NORWALK LA MIRADA UNIFIED SCHOOL DISTRICT
LA MIRADA HIGH SCHOOL NEW FOOTBALL STADIUM PROJECT
13520 ADELA DRIVE, LA MIRADA, CA 90638

ADDENDUM 1

SINGLE LINE DIAGRAM
- MAIN SWITCHBOARD
"MSB"

E1.01

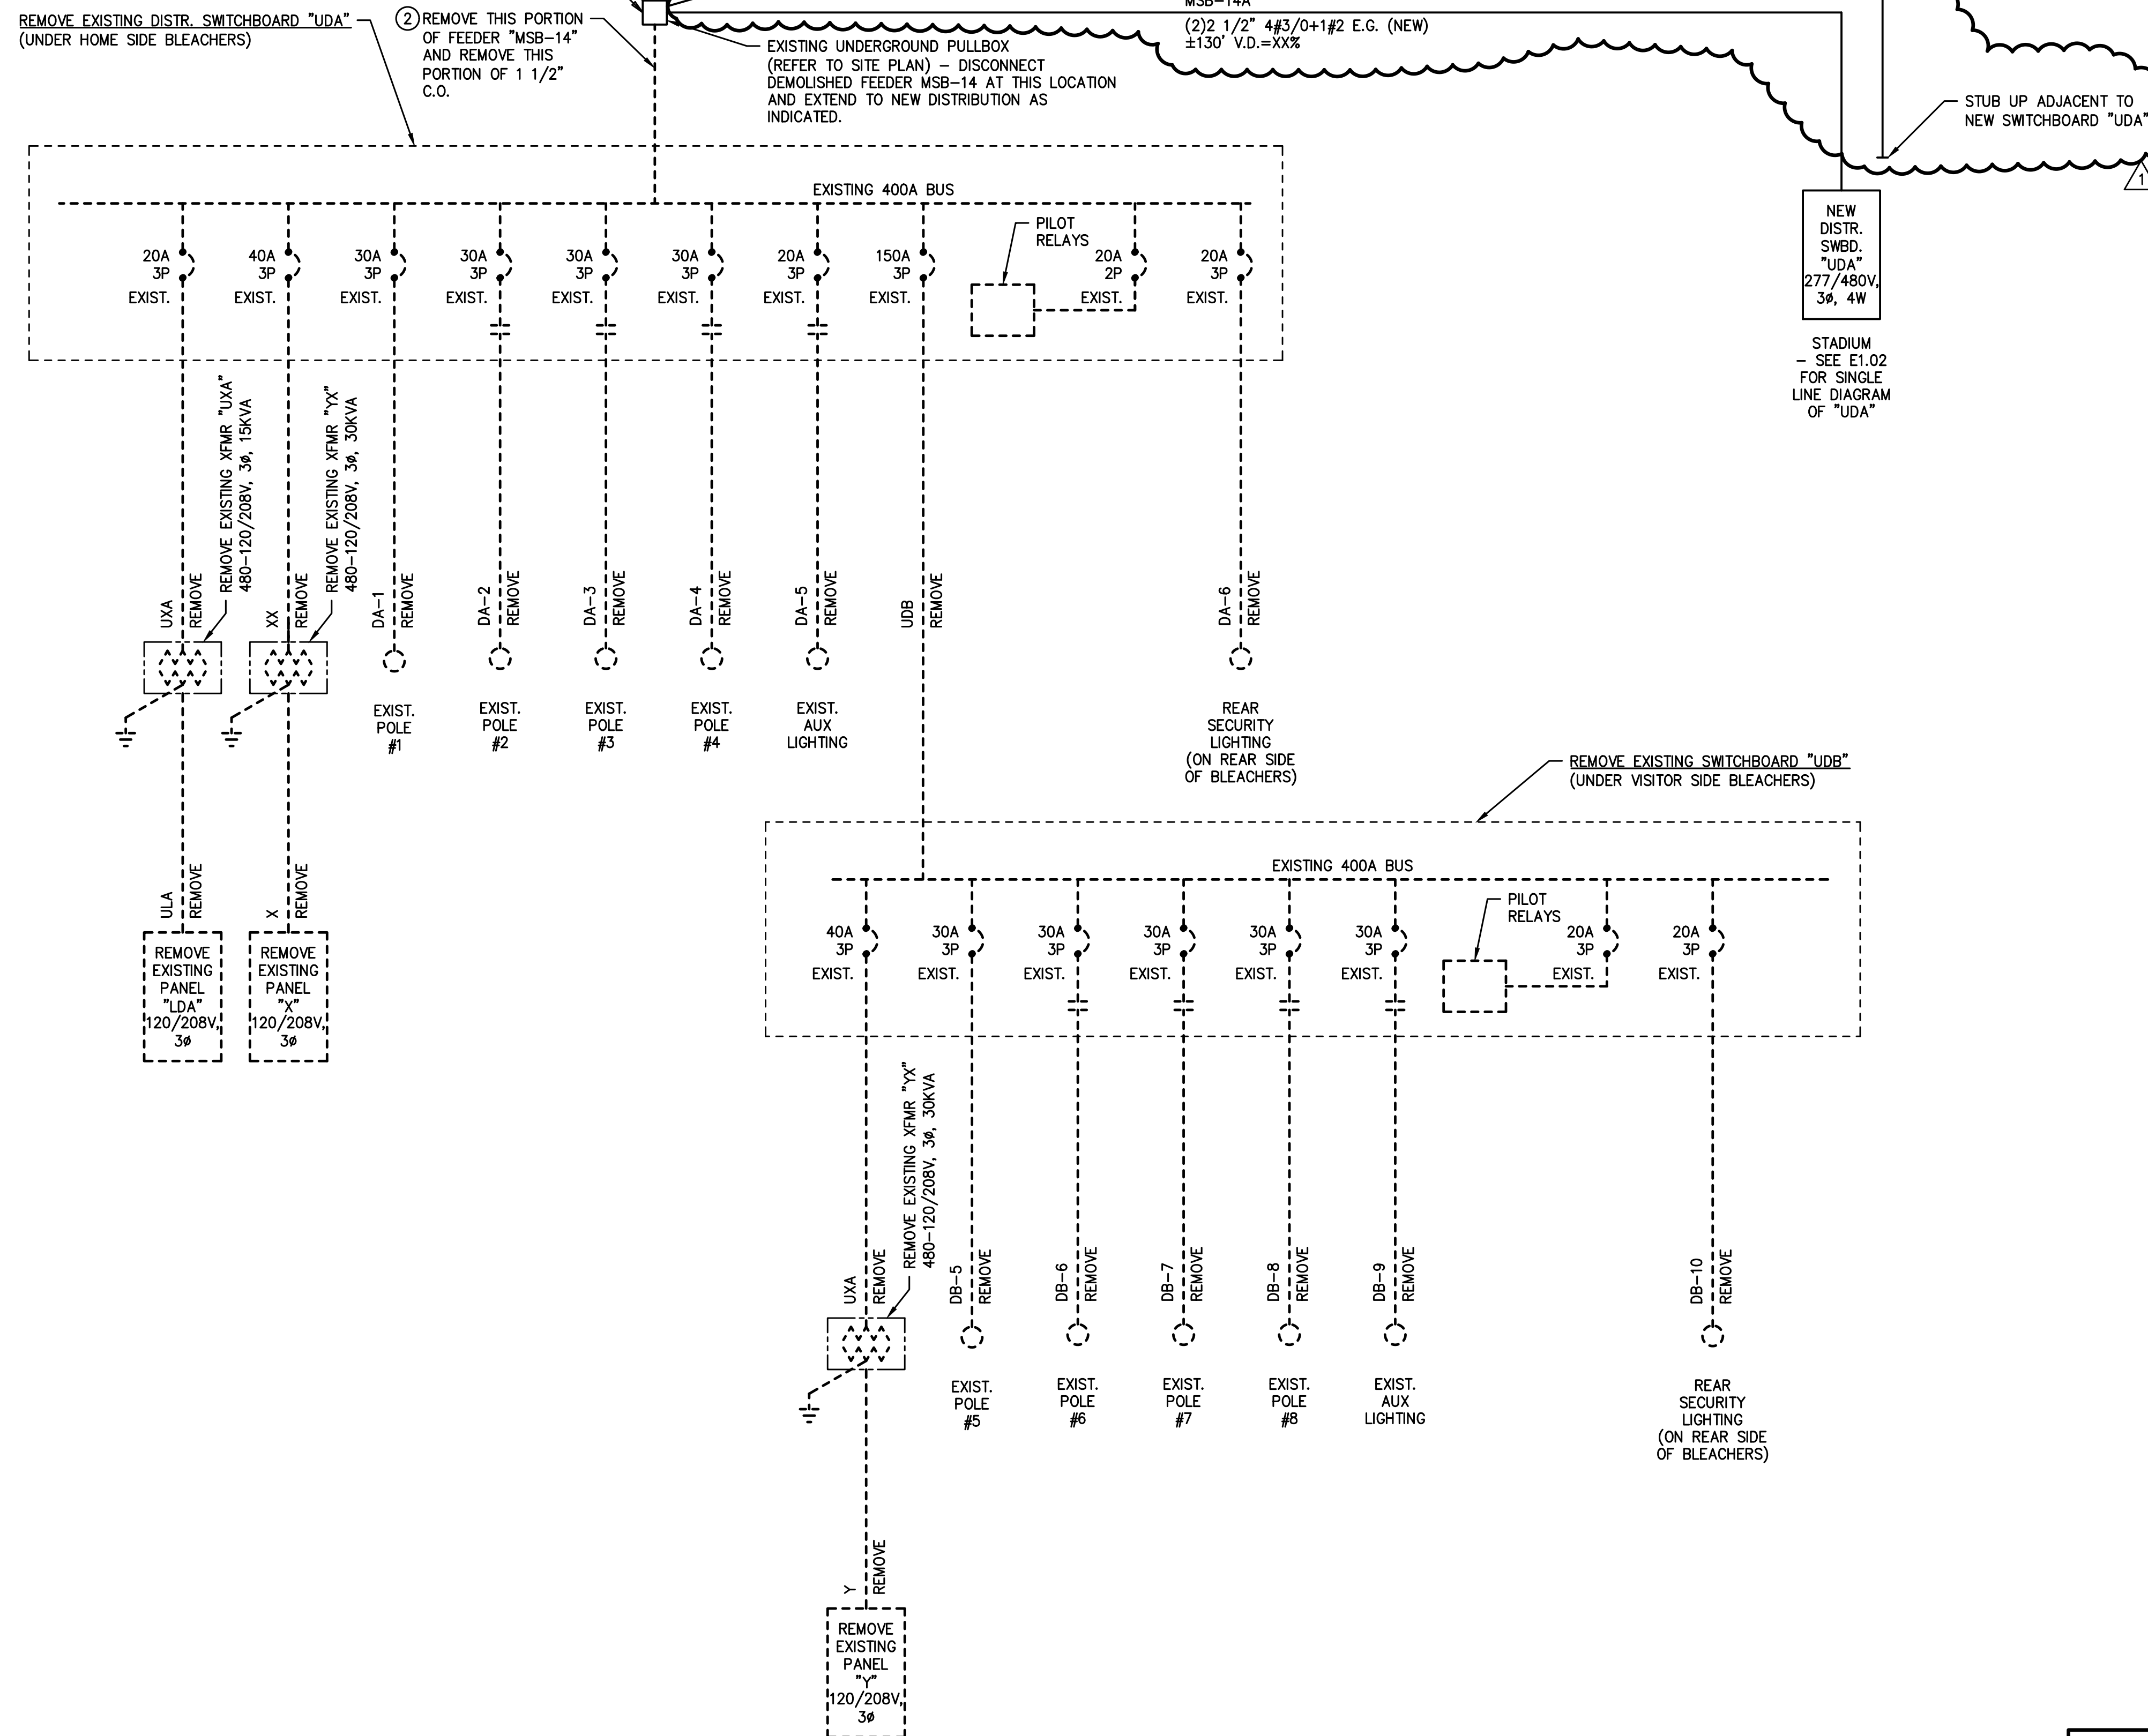
1. ELECTRICAL CONTRACTOR SHALL INSPECT EXISTING GROUNDING AND BONDING FOR CONFORMANCE WITH CEC/NEC ARTICLE 250, FROM POINT OF NEW CONNECTED LOADS BACK TO SERVICE ENTRANCE. IF EXCEPTIONS ARE NOTED, CONTRACTOR SHALL INITIATE RESOLUTION TO ACHIEVE COMPLIANCE REGARDING GROUNDING AND BONDING WITH THE CALIFORNIA/NATIONAL ELECTRICAL CODE.
2. IN ADDITION TO FEEDER MSB-14, THIS RUN INCLUDES A 1 1/2" C.O. FROM MSB TO EXISTING STADIUM.

THIS APPROVAL IS FOR ITEMS WITHIN CLOUDED AREAS ONLY. FOR OTHER INFORMATION NOT CONTAINED WITHIN CLOUDED AREAS, REFER TO ORIGINAL DSA APPROVED PLANS.
